From: Scott Chadwick
Sent: 5/06/2024 7:22:52 AM
To: Council Northernbeaches Mailbox
Subject: TRIMMED: DA 2023 1780 (amended plans)89 MARINE PARADE AVALON
LETTER OF OBJECTION.
Attachments: Amended Plan comments - letter to Northern Beaches Council.pdf;

Re: Commentary regarding **Amended Plans** - DA2023/1780 at 89 Marine Parade, Avalon Beach

Figure 1 – Location of window/door and deck overlooking principle outdoor living area

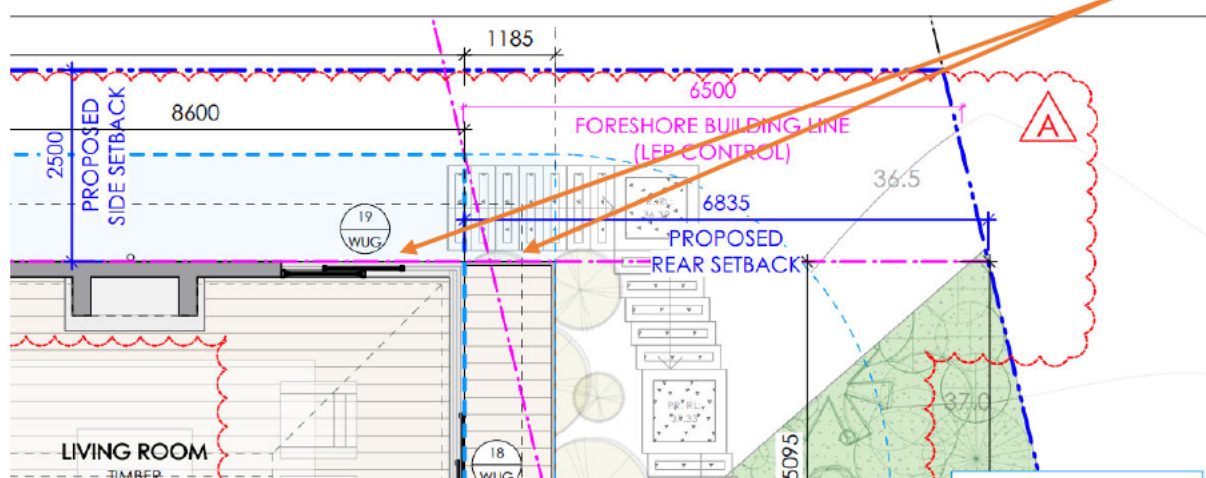
1. **Privacy Impact.** One of key areas of outstanding concern is the loss of privacy resulting from the window/glazed door serving the living room and deck along the northern elevation, looking directly into our principal outdoor living area and bedroom at a distance of less than 9 metres. Figure 1 demonstrates the area of ongoing concern.

Should Council determine to approve the subject DA, despite the ongoing concerns outlined in this letter, it is requested that fixed louvres and a privacy screen are conditioned to the living room window and northern aspect of the deck. It should be noted from the photo montage and your site visit that we have had to install a privacy screen to our balcony at the southern aspect to protect the privacy of our neighbours at 89 Marine Parade. It is reasonable to expect the same level of privacy of our principle outdoor living space and bedroom.

Notwithstanding the above, the deck should be removed at the point where it breaches the Foreshore Building Line.

Figure 3 – Remaining Foreshore Building Line breach

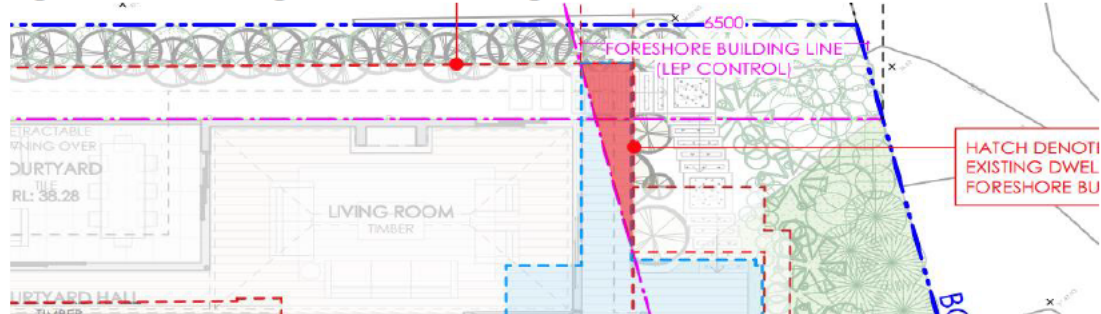
2. **Non-compliant rear setback within the Foreshore Building Line** – As detailed in the previous point and as shown in Figure 3, one of the remaining key areas of concern is the breach to the foreshore building line. This occurs as shown in figure 1 and 3 where the deck extends into the foreshore area. The breach could be resolved by simply pulling back the rear elevation by removing the deck off the Living Room. This amendment would also reduce privacy impacts.

Figure 4– Remaining breach to the side boundary envelope

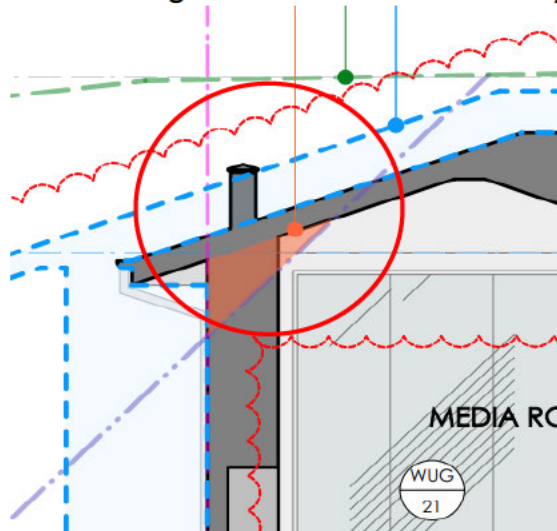
3. **Non-compliant side boundary envelope** - It is acknowledged and appreciated that the side setback has been increased, which has resulted in a reduced side boundary envelope breach. However, given the bulk and scale of the proposed development, a breach at the upper floor elevation still occurs and results in an overbearing and oppressive impact on our amenity. The remaining breach is as shown in figure 4.
